FIRE SAFETY UPGRADE STRATEGY REPORT

220 Bentinck Street, BATHURST NSW 2795

Client:	St Stanislaus College
Reference:	23175
Revision:	02
Date:	11/08/2023

Davis Group has been engaged by St Stanislaus College to prepare a Fire Safety Strategy Upgrade Report for the purposes of Section 64 of the Environmental Planning and Assessment Regulation 2021.

Bounding construction - Ground Storey – Block E

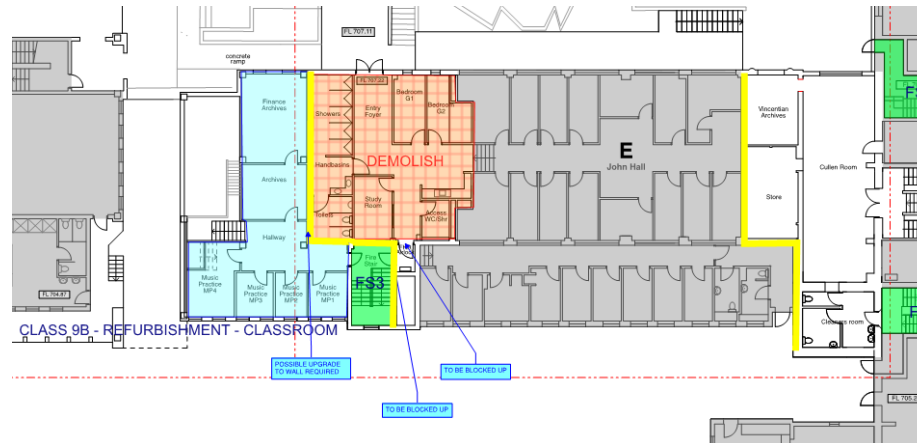
During the site inspection, it was observed a fire wall appears to have been partially constructed from the portico, across the landing and adjacent to the redundant stairway on the Ground Storey (right side on plan below).

It is recommended the wall be extended across the top of the redundant stairway, through the foyer hallway and the existing wall of the sanitary facilities be used as the bounding construction.

The wall highlighted in yellow on the left side of the above plan is a double-brick wall that faces into the undercroft ramp area. It is recommended no upgrades occur to this wall.

Bounding construction – Upper Ground Storey – Block E

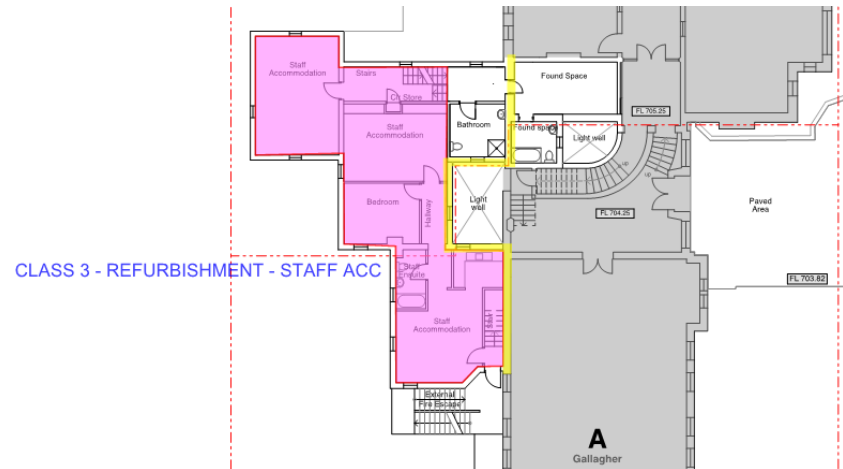
The wall located between the Class 9b classroom and floor area to be demolished contains an opening (possibly an old doorway) in the masonry construction that does not appear to be of fire-resisting construction. Refer to the photograph below.

It is recommended the infill material be removed and the opening be upgraded to achieve an FRL of at least 90/90/90.

Bounding construction - First Storey – Block D

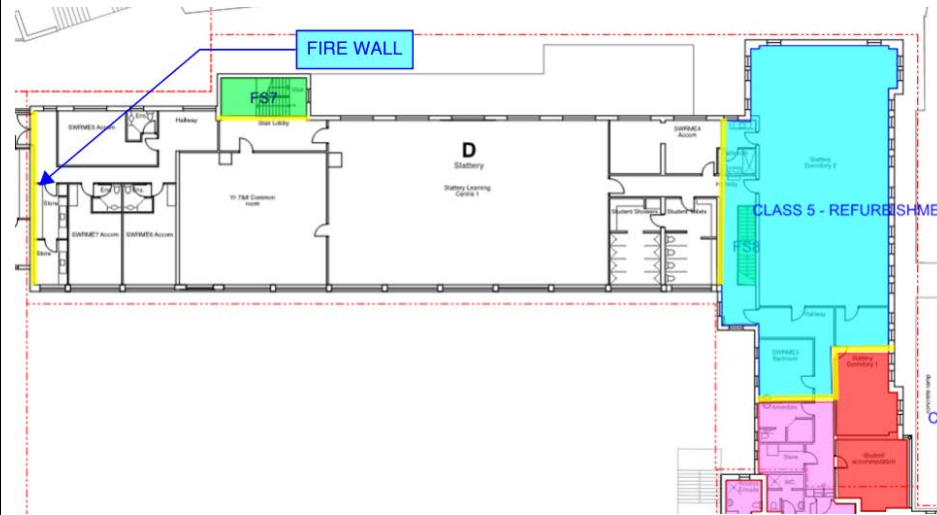
The First Storey of Block D is partially used for the purpose of a dormitory. The western wall is marked up in yellow but proposed to be a fire wall as detailed in C3D8 of this report.

It is recommended the other areas highlighted in yellow be provided as bounding construction to the Class 3 parts of the building.

Bounding construction - Second Storey – Block B, C and E

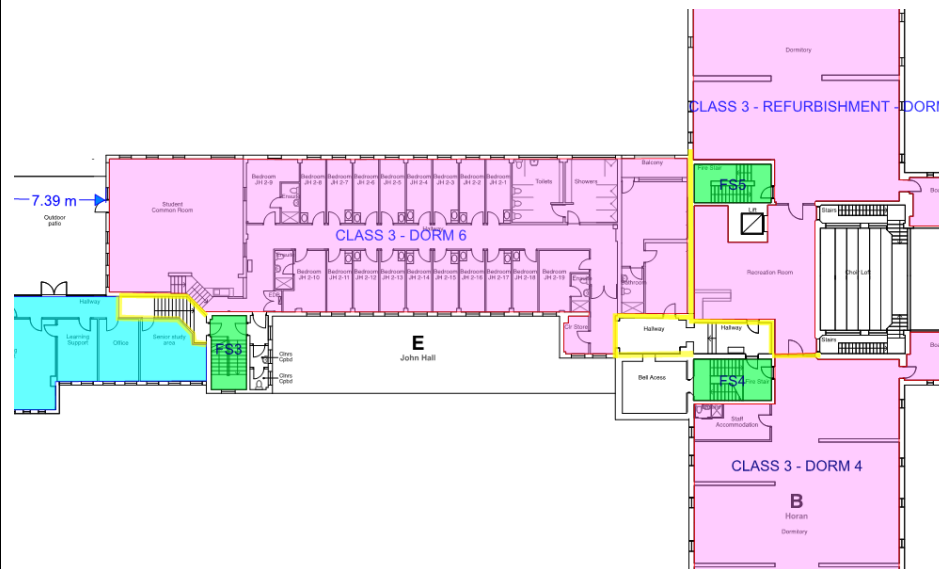
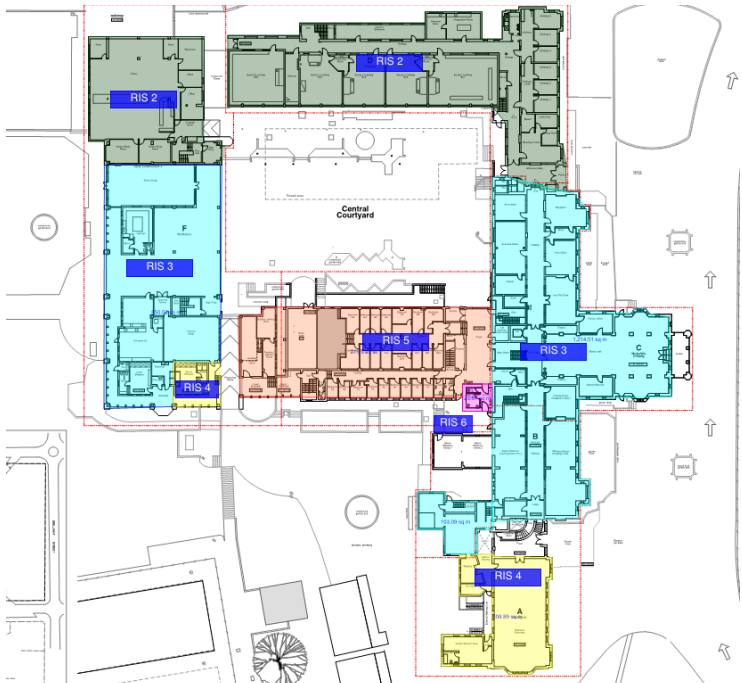
It is recommended the walls highlighted in yellow be provided as bounding construction to the Class 3 parts of the building and the proposed public corridors associated with the Class 3 parts.

The wall adjacent to the light blue part of Block F is proposed to be bounding construction for a public corridor. However, it is also indicatively proposed to be a fire wall with a FRL of 120/120/120. Refer to the comments in C3D8 of this report. The fire wall has the higher FRL and the wall is required to achieve a FRL of 120/120/120.

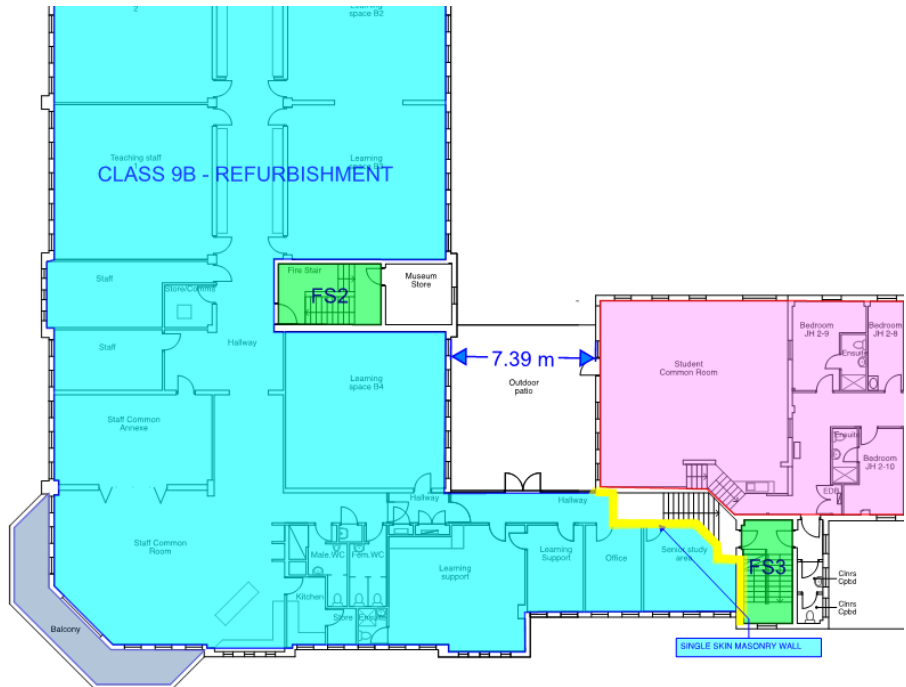
C3D8 [C2.7]	Separation by fire walls	It is recommended Block F be separated from the remainder of the building by fire walls that achieve a FRL of at least 120/120/120. The general location of the proposed walls are highlighted in yellow on the floor plans below, however, the exact location may be varied as the design progresses during the construction certificate phase. <u>Ground Storey</u>  The fire walls located near Block F and E, and Block F and D does not extend through the undercroft area. It is recommended the windows in the wall of the library and the lack of fire wall adjacent to the library in these parts of the building be upgraded to comply with the Performance Requirements of the BCA via a Performance Solution prepared by a Certifier – Fire Safety	Upgrade Recommended/ Performance Solution
------------------------	---------------------------------	--	---

The existing wall between Block D and F is a double masonry wall that is likely to achieve a FRL of 120/120/120. The fire wall between Block F and E is also a masonry double masonry wall that is likely to achieve a FRL of 120/120/120.

Second Storey The existing wall between the hallway and staff rooms is a single skin masonry wall that is unlikely to achieve a FRL of at least 120/120/120.  The floor plan shows a large cyan-colored area labeled 'CLASS 9B - REFURBISHMENT' which includes 'Teaching staff', 'Learning', 'Staff', 'Hallway', 'Staff Common Area', and 'Staff Common Room'. A green area labeled 'FS2' is also shown. To the right, a pink area is labeled 'Student Common Room' and includes 'Bedroom JH 2-3', 'Bedroom JH 2-4', and 'Bedroom JH 2-10'. A blue arrow indicates a distance of '7.39 m' between the cyan area and the pink area. A yellow line highlights a 'SINGLE SKIN MASONRY WALL' between the two areas. Other rooms include 'Learning space D4', 'Learning support', 'Office', 'Service study area', 'FS3', 'Kitchen', 'Male WC', 'Female WC', 'Museum Store', 'Balcony', and 'Chris Cptd'. It is recommended the existing wall be upgraded to achieve a FRL of at least 120/120/120. It is also recommended separation through the junction/ eaves of the hallway, outdoor patio, external walls and student common room be reviewed by a Certifier – Fire Safety	Upgrade Recommended/ Performance Solution

Upper Ground Storey – Fire stair 3 and 4

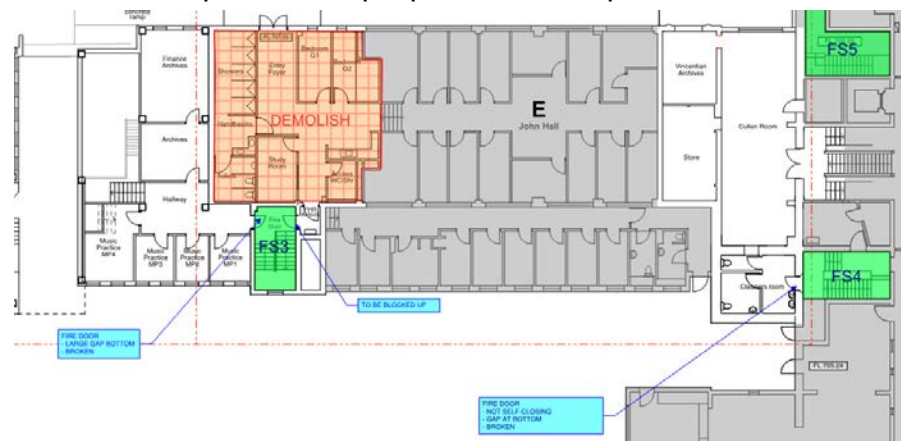
The fire doors in fire stairs 3 and 4 are damaged and contain excessive gaps. The entry into fire stair 3 (eastern side) is to be filled in as part of the proposed development.

It is recommended the damaged and untagged fire-doors to fire stairs 3 and 4 be removed and replaced with new -/60/30 fire doors to comply with C4D9. The entry into fire stair 3 (eastern side) be filled in with masonry construction to achieve a FRL of at least 120/120/120 to comply with Specification 5.

First Storey – fire stair 3, 4 and 5

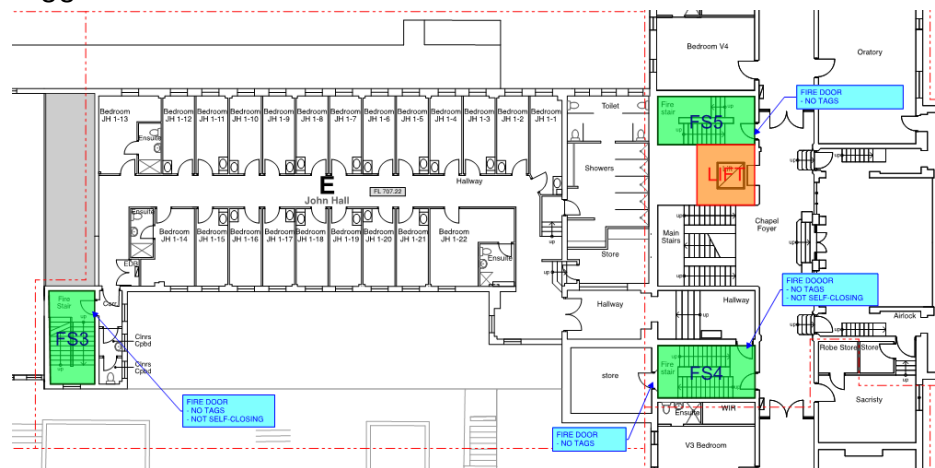
The fire doors in fire stairs 3, 4 5 are not self-closing or not tagged as fire doors.

It is recommended the damaged and untagged fire-doors to fire stairs 3, 4 and 5 be removed and replaced with new -/60/30 fire doors to comply with C4D9.

Second Storey – Fire stair 3, 4 and 5

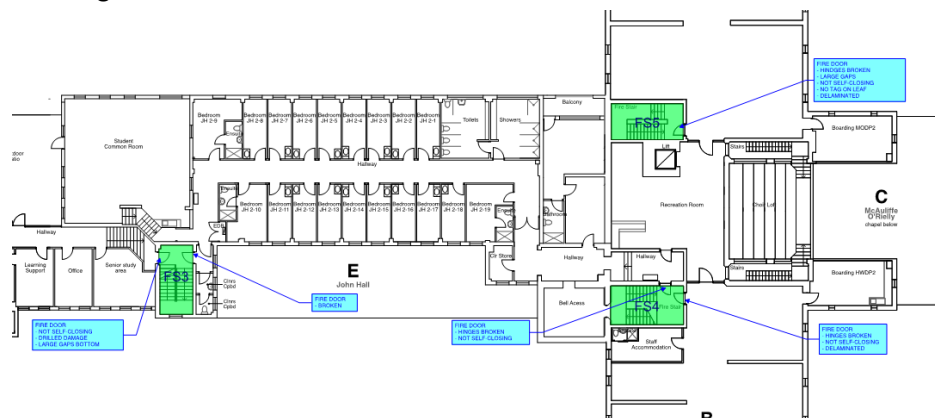
The fire doors in fire stairs 3, 4 and 5 are not self-closing, not tagged as fire doors, contain excessive gaps or are significantly damaged/ broken.

It is recommended the damaged and untagged fire-doors to fire stairs 3, 4 and 5 be removed and replaced with new -/60/30 fire doors to comply with C4D9.

Block A – Second Storey – Boarders Recreation

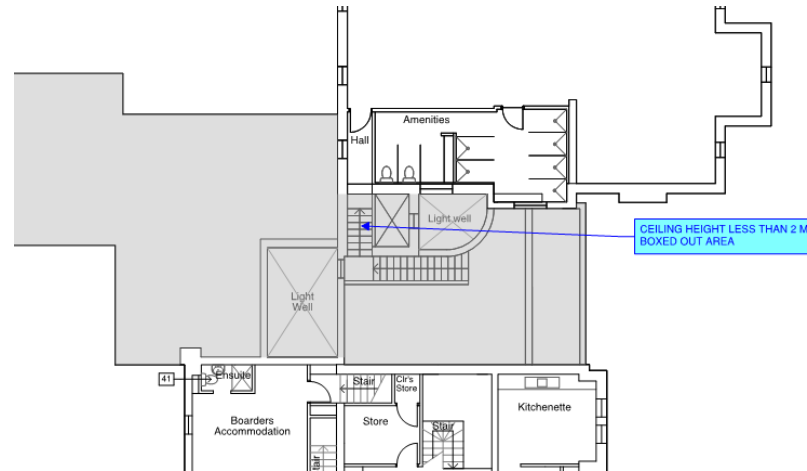
Part of the boarders recreation contains a sloped ceiling that has a height (near the external wall, refer to photograph above) that is less than 2 m, which is contrary to D2D7.

Block D – Sanitary Compartments

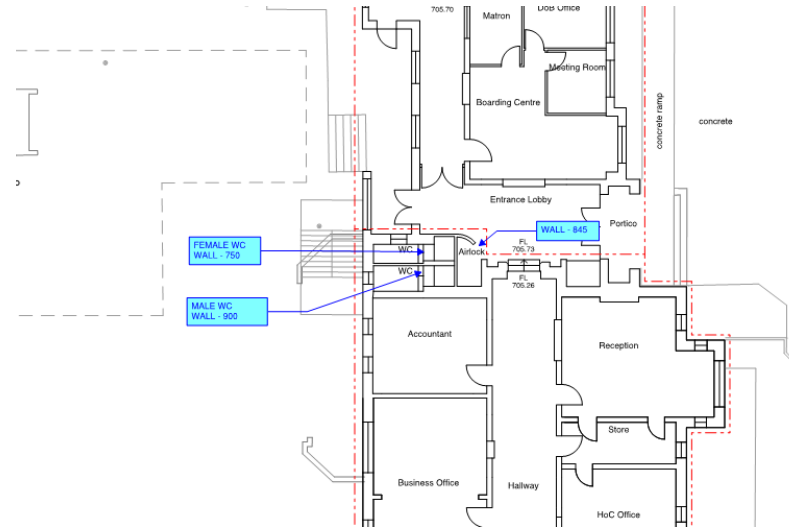
The unobstructed egress width from the sanitary facilities on the Ground Storey of Block D vary between 760 mm and 845 mm, in lieu of 1 m, which is contrary to D2D8(1)(a).

Block C – Second Storey – Fire Stair 9

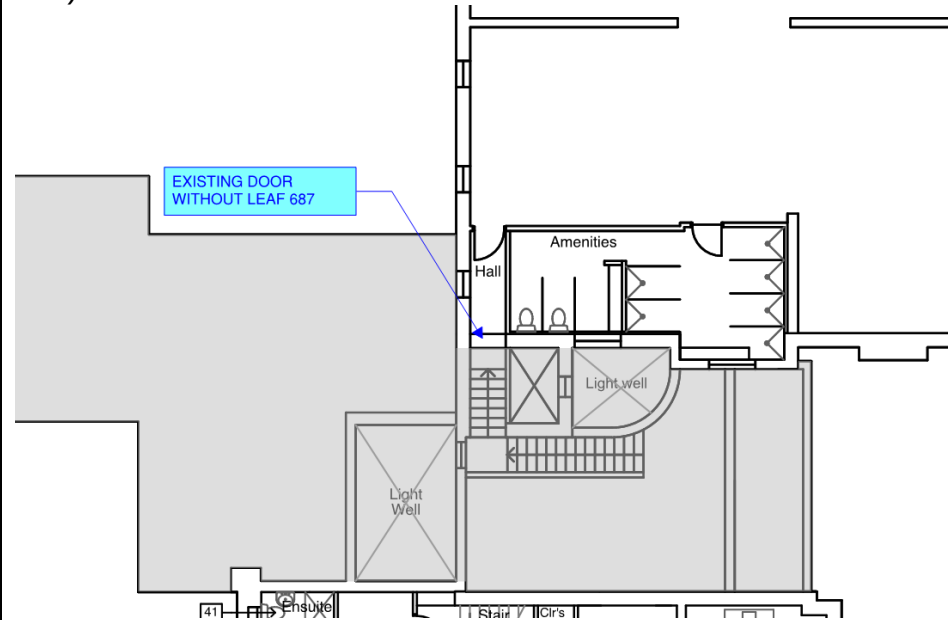
The existing doorway located at the top of fire stair 9 does not contain a door leaf. The proposed development includes construction of a new door leaf. The existing opening (without a leaf) has an unobstructed width of 687 mm.

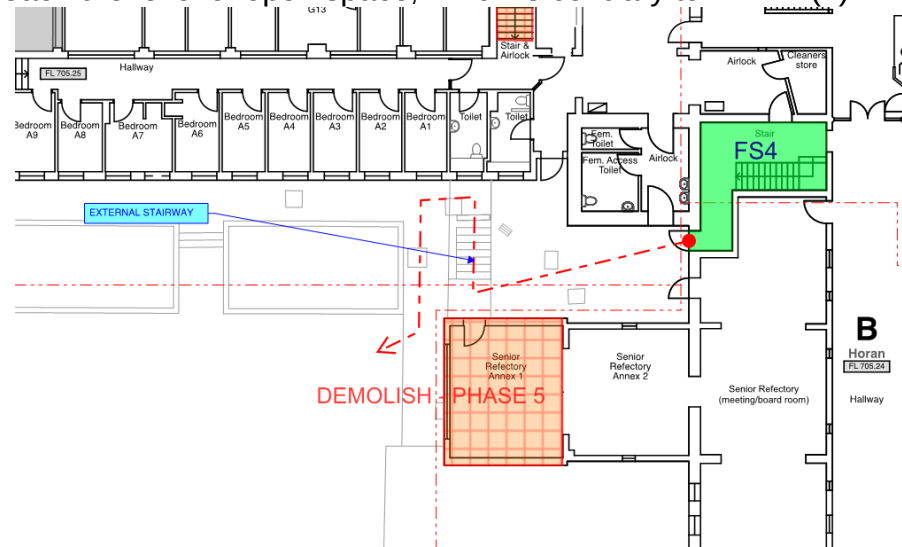
D2D12 [D1.7]	Travel via fire-isolated exits	<u>Fire Stair 3 – Ground Storey - Discharge</u> Fire stair 3 currently has two points of discharge, being the Ground Storey and Basement. This is proposed to be rectified as part of the proposed development and the only point of discharge will be at the basement (lowest level). No further upgrade is recommended. <u>Fire Stair 3 – Basement - Discharge</u> The marked up floor plan shows the existing configuration for egress from fire stair 3. The discharge location is not open for at least 1/3 of the perimeter and does not have an unobstructed clear height throughout of at least 3 m. Additionally, the existing door to the toilets is not a self-closing fire door that achieves an FRL of at least -/60/30.  The following marked up floor plan shows the proposed configuration. The discharge location is not open for at least 1/3 of the perimeter and does not have an unobstructed clear height throughout of at least 3 m, which is contrary to D2D12(c).	No Upgrade Upgrade Recommended/ Performance Solution

It is recommended the discharge location (into the awning) of fire stair 3 be upgraded to comply with the Performance Requirements of the BCA via a Performance Solution prepared by a Certifier – Fire Safety.

Fire Stair 4 – Rooms opening into the exit

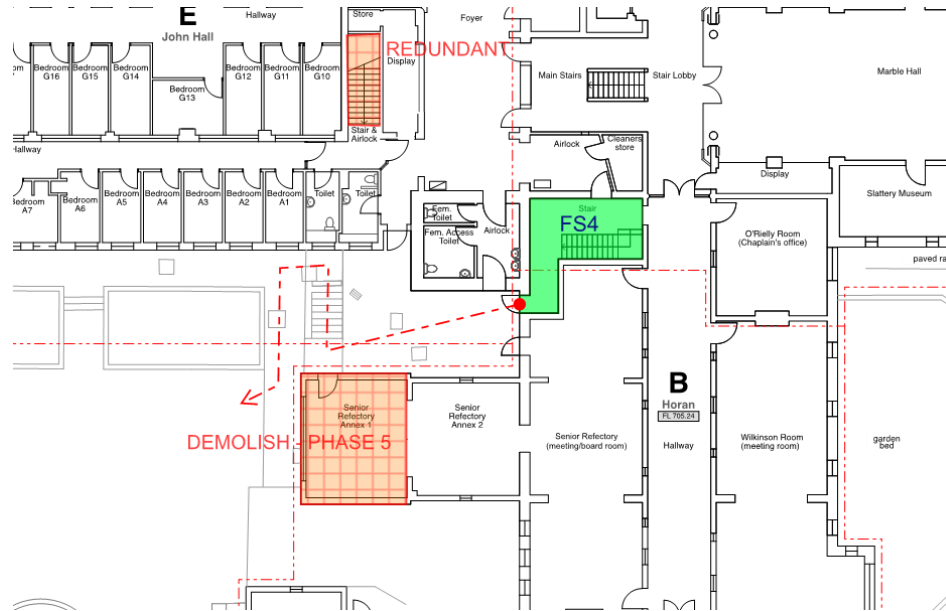
Fire stair 4 contains rooms that are accessed via doorways located on the mid-landings of the fire-isolated exit. The doorways open directly into the fire-isolated exits, which result in three access doorways being provided into the fire stair at a single storey (including the mid landing). Refer to the marked-up floor plan above.

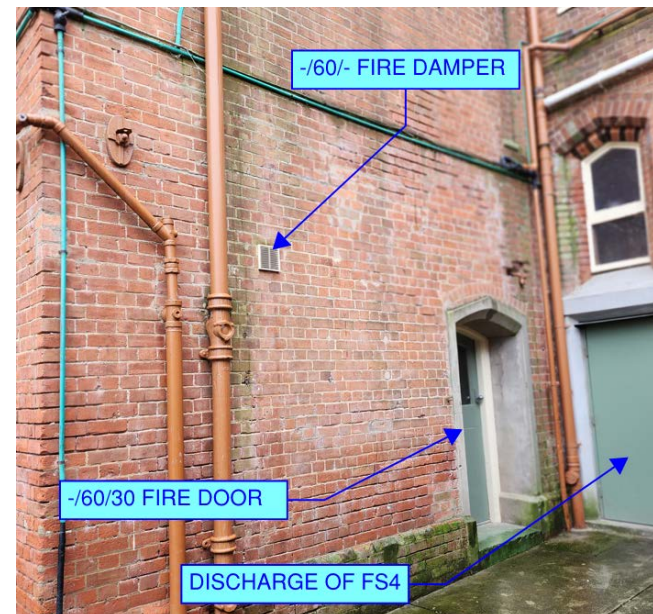
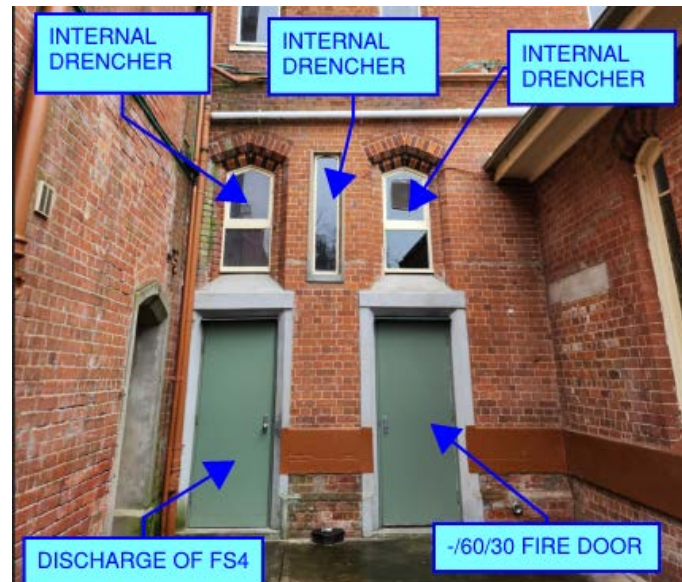
Fire stair 4 discharges into a courtyard that contains multiple unprotected openings. The openings are located within 6 m (measured at right angles) and less than 3 m above the path of travel. The marked up floor plan shows the discharge location and path of travel to the open space.

It is recommended the existing windows within 6 m (measured at right angles) up to a height of 3 m above the path of travel are permanently fixed in the closed position and protected with internal wall-wetting sprinklers to comply with D2D12(3), the air duct be protected by a -/60/- fire damper and the doors be protected by self-closing -/60/30 fire doors. The following marked up photographs show the recommended works.

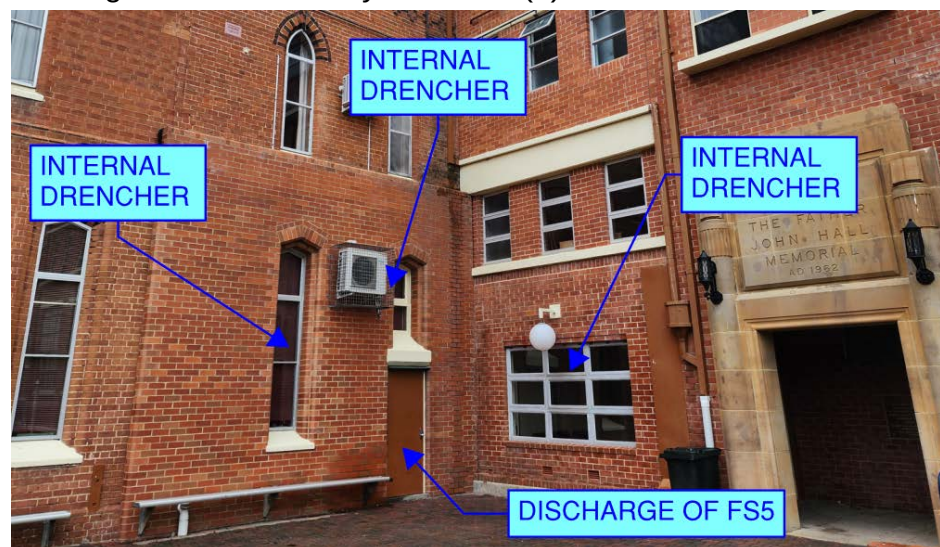
The discharge location of fire stair 5 requires occupants to walk past multiple unprotected windows, immediately after exiting the building, which is contrary to D2D12(3).

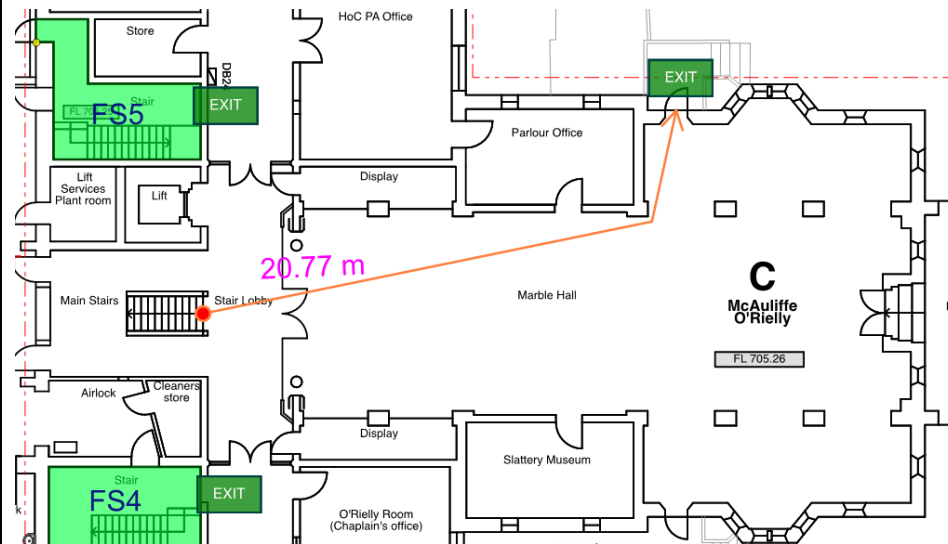
The main stairs serve as a required exit from the First Storey Chapel (due to the required minimum egress width). The non-fire-isolated stairway discharges into part of the building that is not only used for pedestrian movement and is located more than 20 m from the exit to the road/ open space, which is contrary to D2D12(2)(b).
